**FINDINGS AND RECOMMENDATION
OFFICE OF PLANNING AND ZONING
ANNE ARUNDEL COUNTY, MARYLAND**

CASE NUMBER: 2024-0113-V

The applicants are requesting a variance to allow a dwelling addition (3 story) with disturbance to slopes of 15% or greater and less setbacks than required on property located at 614 Tower Bank Road in Severna Park.

SITE DEVELOPMENT PLAN

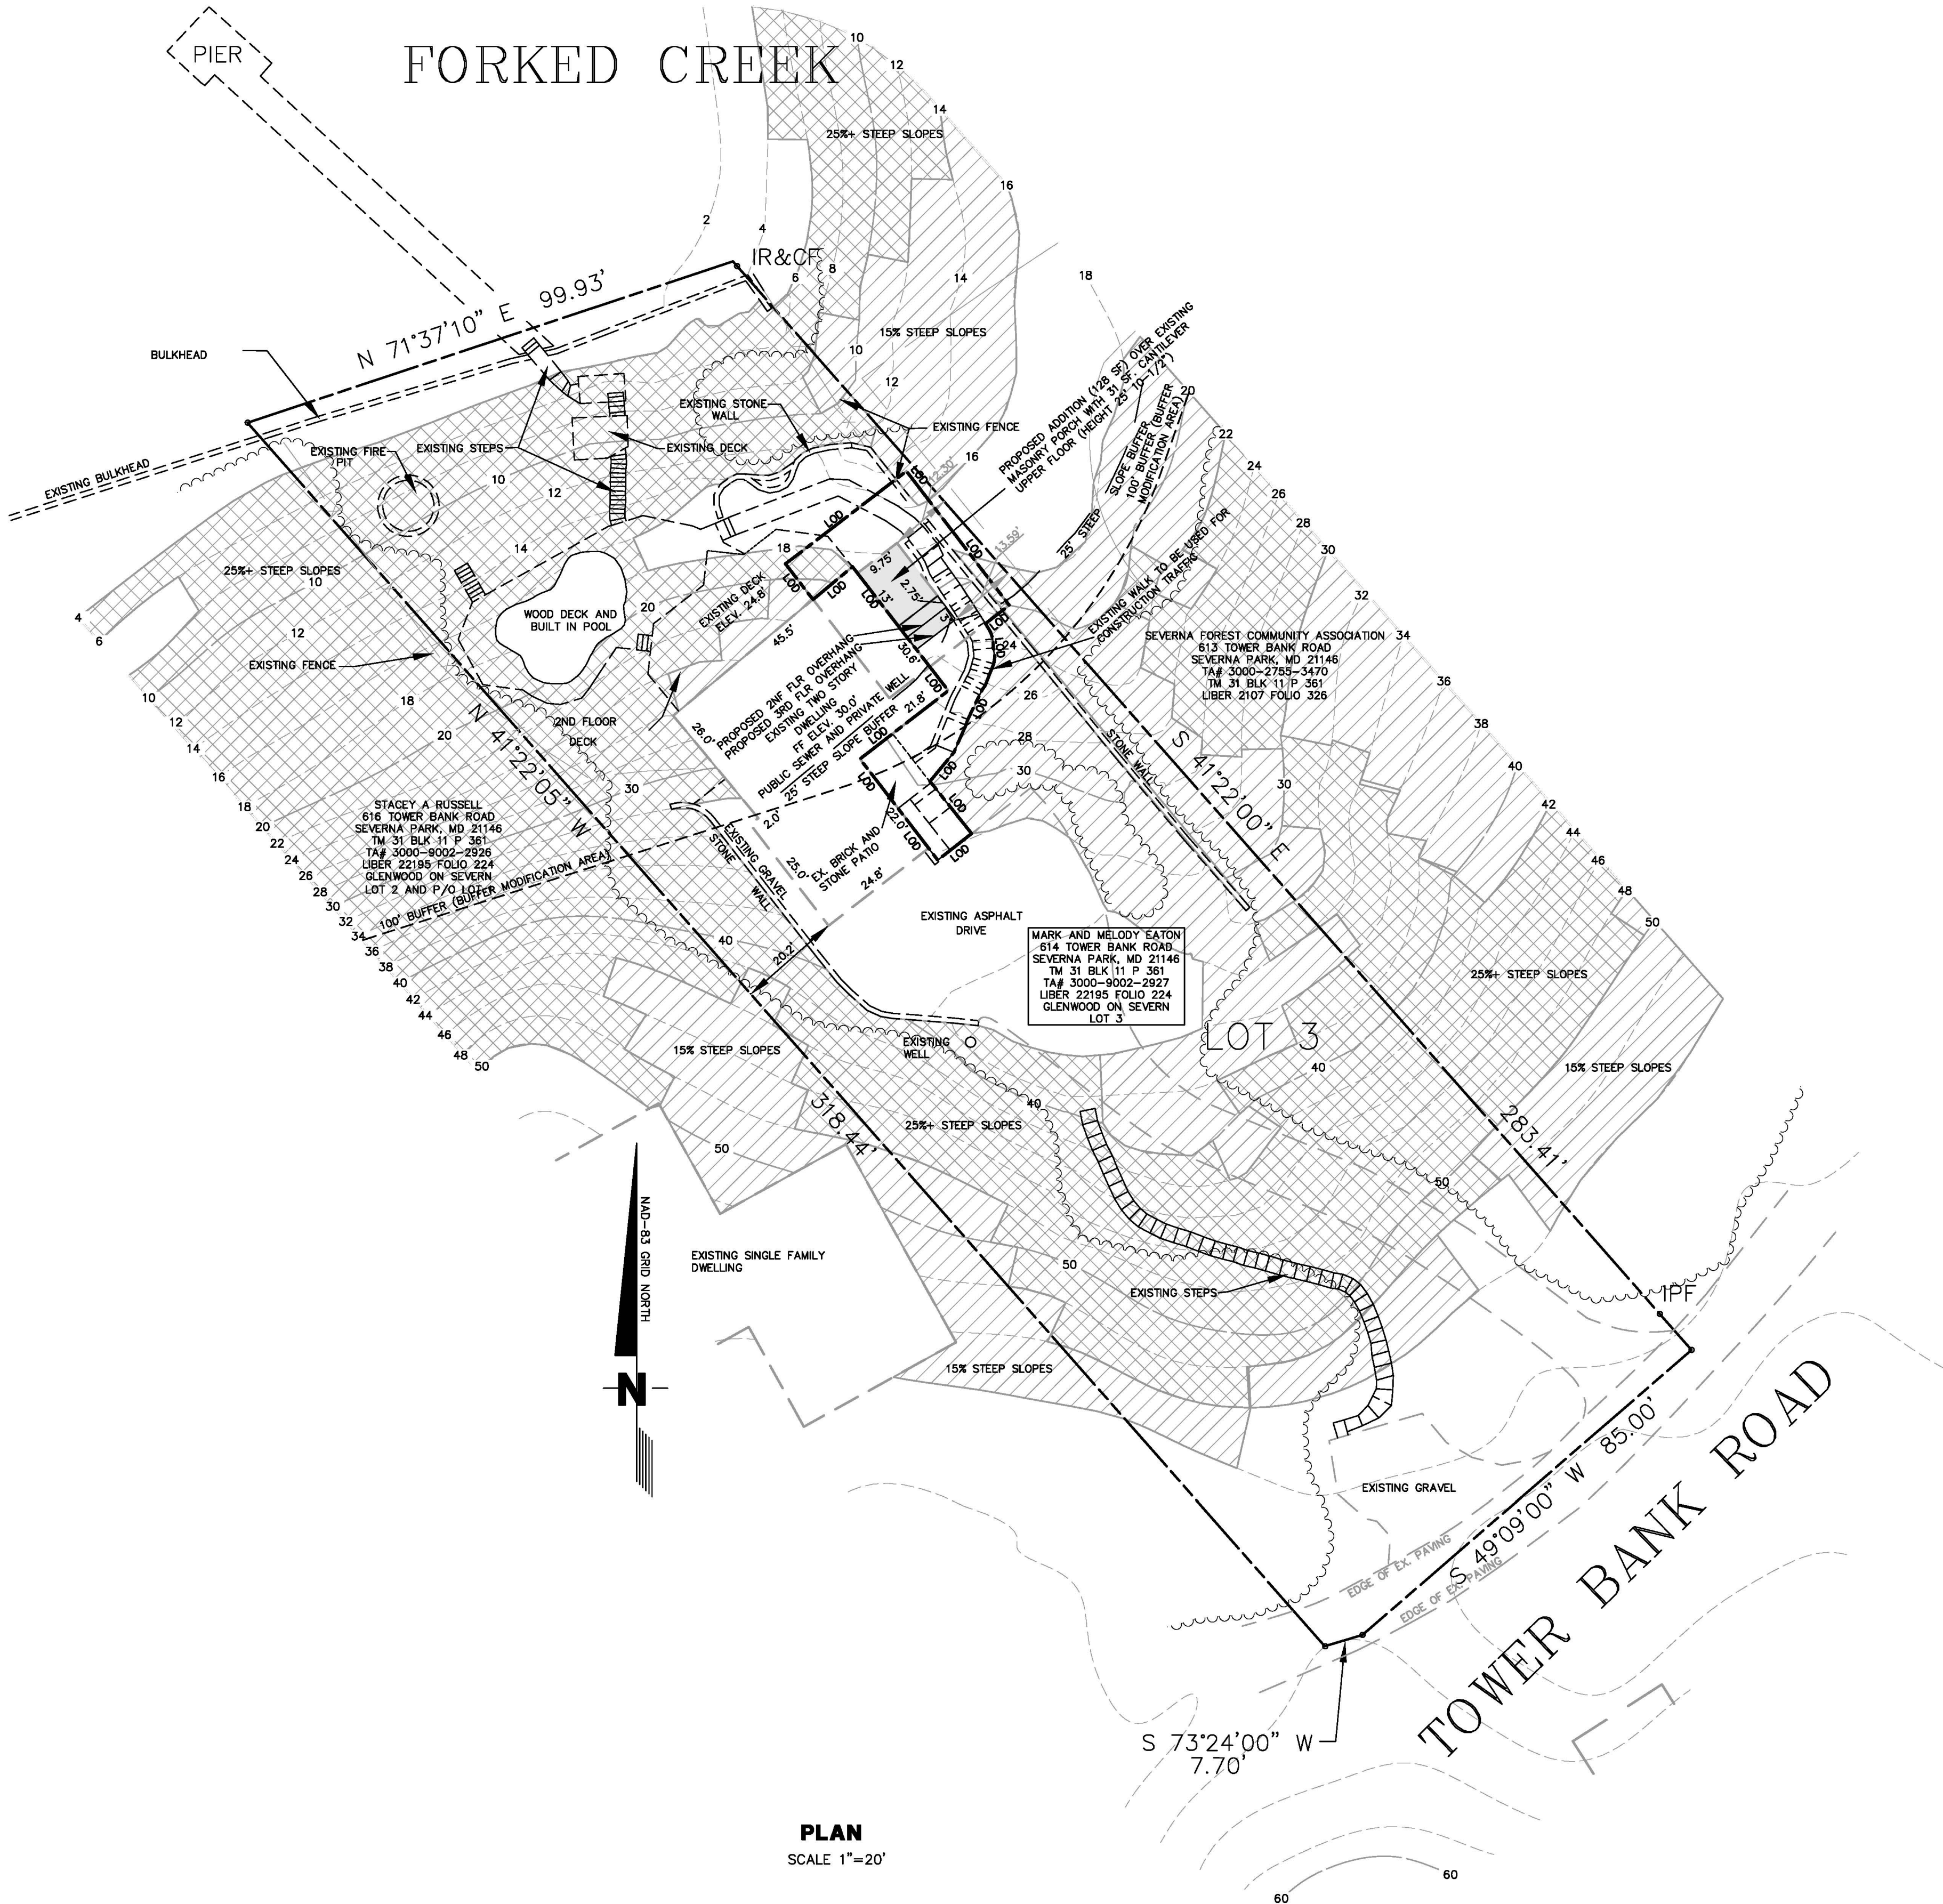
- The proposed construction will disturb approximately 550 square feet of slopes of 15% or greater, necessitating a variance. The final amount of disturbance will be determined during permit review.

The existing and proposed post-construction critical area lot coverage of the site is 6,817 square feet, which exceeds the lot coverage allowed under § 17-8-402 (5,445 square feet). § 17-8-403 states that the reconfiguration of lot coverage shall result in a 10% reduction of the amount of impervious surfaces that exceed the maximum permitted lot coverage. The reduction required for the removal of the existing porch and the construction of the addition is 137.2 square feet (or 10% of 1,372 square feet), and will be verified at permitting. The existing and proposed post-construction coverage by structures is 2,301 square feet, which is well below the 25% (6,954.25 square feet) maximum coverage by structures allowed under § 18-4-501.

The **Health Department** noted that they do not have an approved plan for this project, but has no objection as long as a plan is submitted and approved by their Department.

The **Critical Area Commission** noted that appropriate mitigation is required.

The **Critical Area Team** has no objection to this request, and noted that mitigation will be addressed with the permit application.

proposed addition has been designed within the footprint of the existing porch, therefore the disturbance to the slopes will be temporary.

If granted, the final amount of disturbance will be determined during permit review.

In addition, if granted, per § 17-8-702(e), mitigation for new lot coverage or for replacement of existing lot coverage in the buffer modification area is required as follows:

- (1) For every square foot of additional lot coverage within 100 feet of the mean high water line, a vegetated buffer shall be planted within the buffer modification area at a ratio of two times the amount of lot coverage.
- (2) If a variance is required, a vegetated buffer shall be planted within the buffer modification area at a ratio of 3:1 for the additional area of disturbance granted under the variance.
